October 30, 2014

**Re: Surface Water Drainage to Camp Lake Near Freshwater Intake – Sedimentation Control Plan
Mary River Project – Water License No. 2AM-MRY1325**

Re: Surface Water Drainage to Camp Lake
Mary River Project – Water Licence No. 2AM-MRY1325

QIA INSPECTION REPORTS AND BAFFINLAND RESPONSES

Figure 1 – Location of Settling Ponds

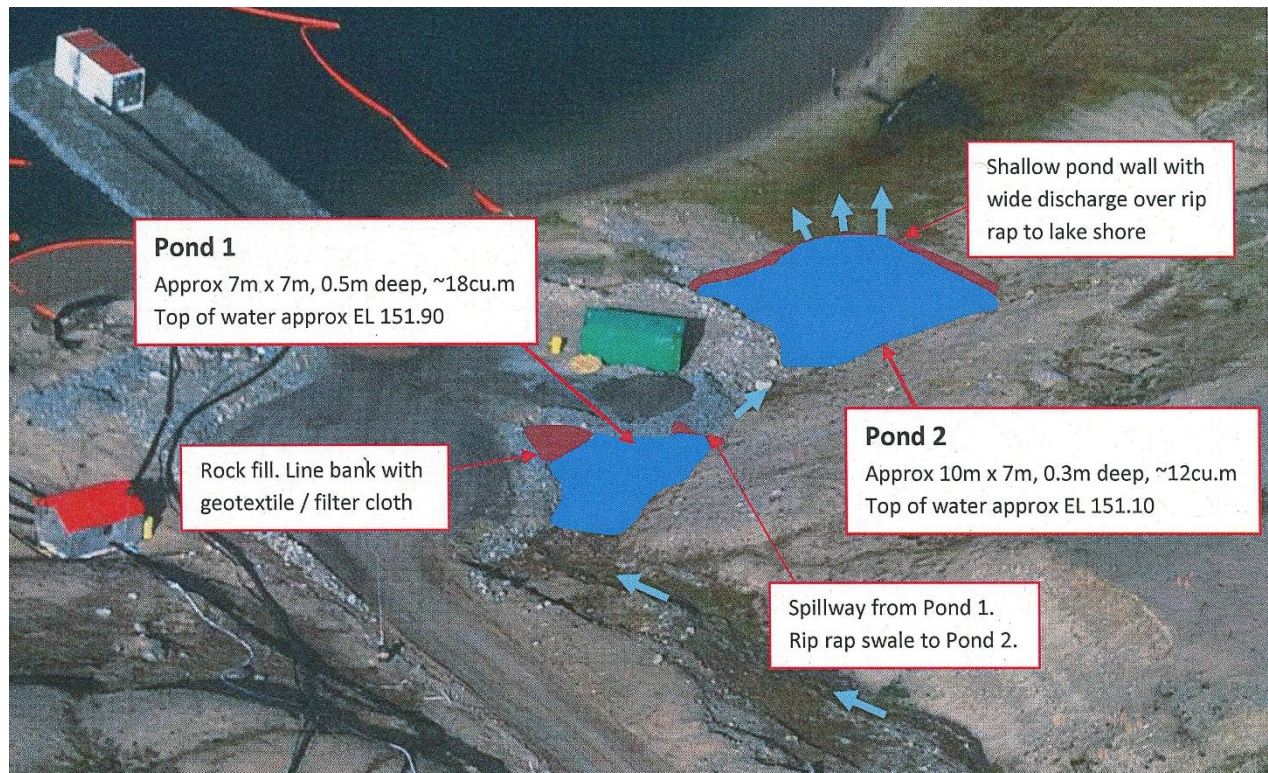
Sediment control of the surface water drainage to Camp Lake will be controlled by means of the of two successive settling ponds at the base of the drainage that will be constructed by means of a mechanical excavator. The ponds will decrease the flow velocity and in turn provide additional time to allow for the settling out of suspended sediments prior to the runoff entering Camp Lake (refer to Figure 2). The upstream and downstream settling ponds will have an approximate capacity of 18 cubic metres and 12 cubic metres, respectively. The pond banks and the spillway which connects the two ponds, as well as the outflow location of the ponds will be constructed using coarse rock material and will be lined with geotextile to reduce the possibility of erosion during high intensity flows. The ponds will be periodically monitored and deposited sediment excavated as required to maintain pond capacity and run-off retention times.

Constuction of the settling ponds is scheduled to be completed prior to freshet 2015 or when subsurface conditions allow. A silt curtain will be installed at the outlet to the new drainage discharge and will be maintained during the 2015 open water season to control any residual sediments from construction or from very high flow rainfall/snowmelt events.

Figure 1 – Location of Settling Ponds

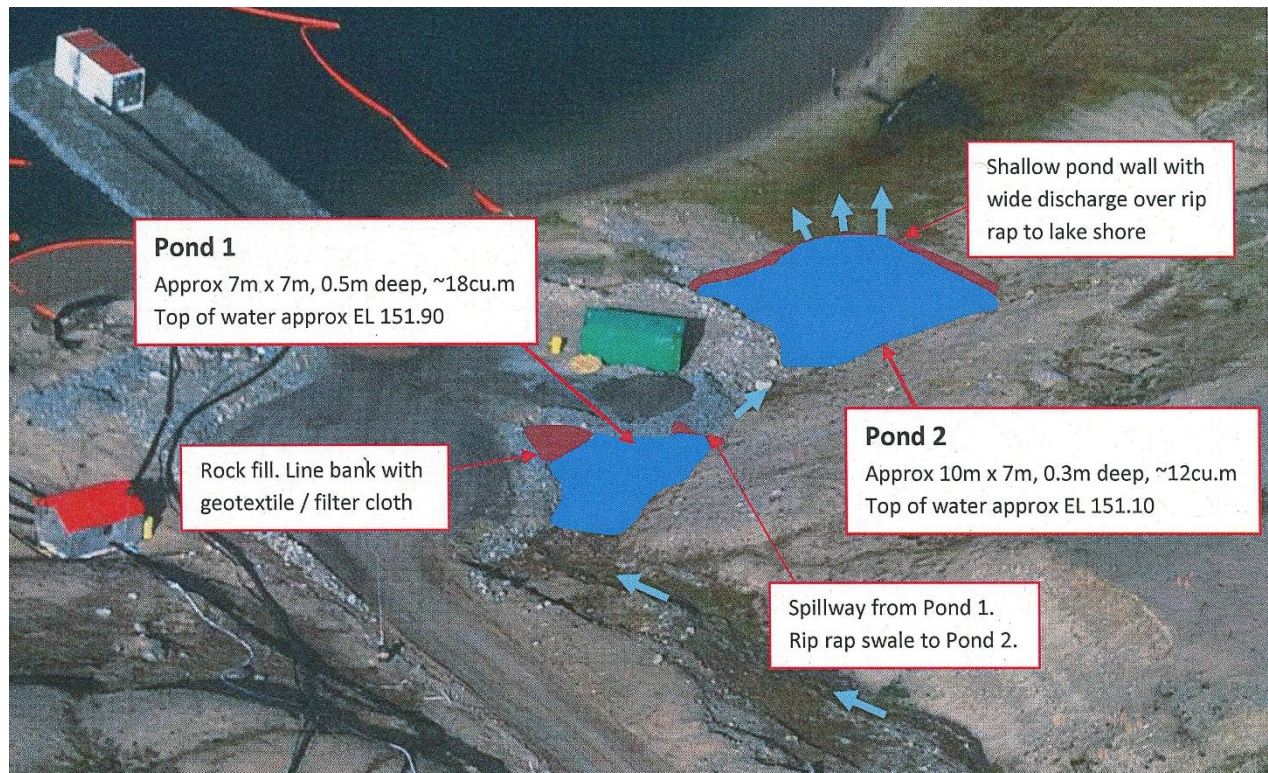
Sediment control of the surface water drainage to Camp Lake will be controlled by means of the of two successive settling ponds at the base of the drainage that will be constructed by means of a mechanical excavator. The ponds will decrease the flow velocity and in turn provide additional time to allow for the settling out of suspended sediments prior to the runoff entering Camp Lake (refer to Figure 2). The upstream and downstream settling ponds will have an approximate capacity of 18 cubic metres and 12 cubic metres, respectively. The pond banks and the spillway which connects the two ponds, as well as the outflow location of the ponds will be constructed using coarse rock material and will be lined with geotextile to reduce the possibility of erosion during high intensity flows. The ponds will be periodically monitored and deposited sediment excavated as required to maintain pond capacity and run-off retention times.

Constuction of the settling ponds is scheduled to be completed prior to freshet 2015 or when subsurface conditions allow. A silt curtain will be installed at the outlet to the new drainage discharge and will be maintained during the 2015 open water season to control any residual sediments from construction or from very high flow rainfall/snowmelt events.
